NUMBER
DEP16323

Addendum Number: 01

**Addendum #1 - Questions During Pre-Bid Conference
For DEP16323
Ed-E Development Co., Inc.
Permit S-10-81**

SLUDGE CELLS
DETAIL DRAWINGS

SHT. NO.
22-R
TOTAL
22

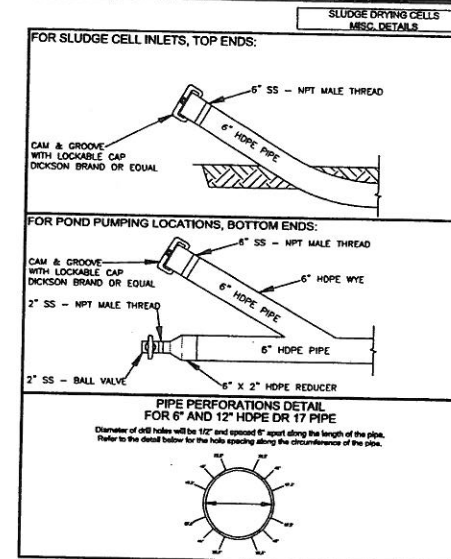
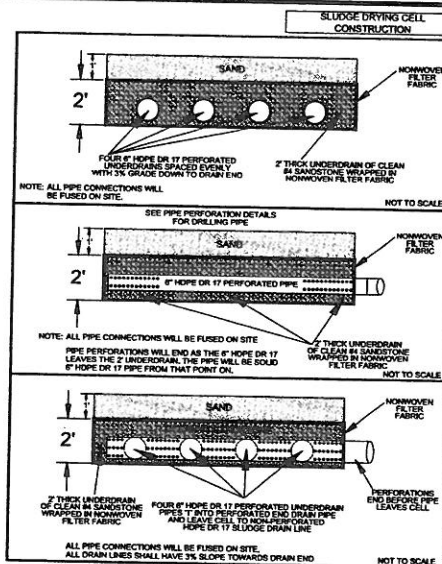
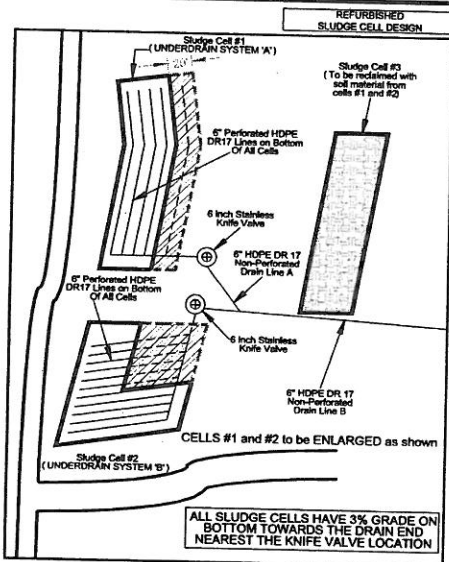
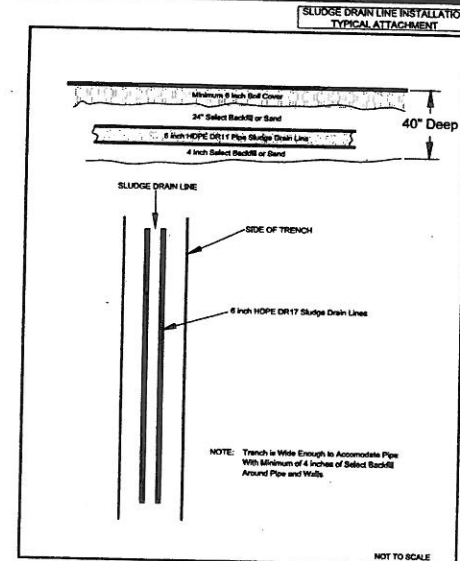
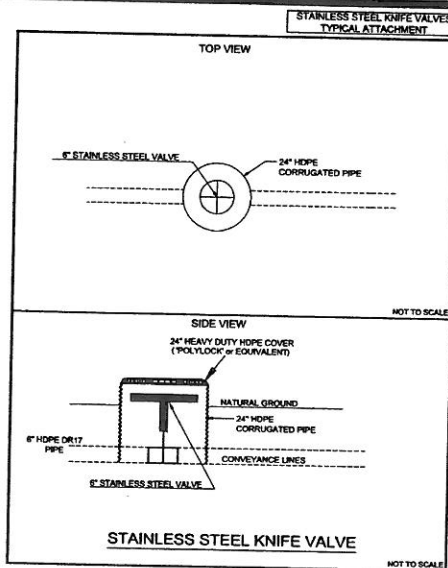
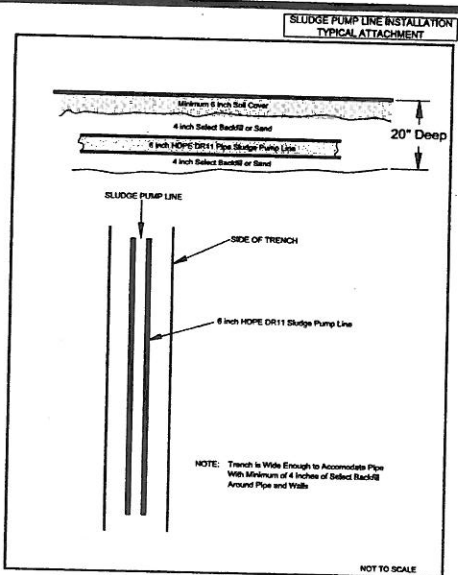
REVISED DRAWING: Sheet 22 has been revised to list the correct aggregate size for the sludge cell underdrain as clean #4 sandstone. Revised drawings have the designation "R" such as 22.0-R.

DATE	BY	COMMENT
10/20/13	SRN	PREPARED ADDENDUM #1
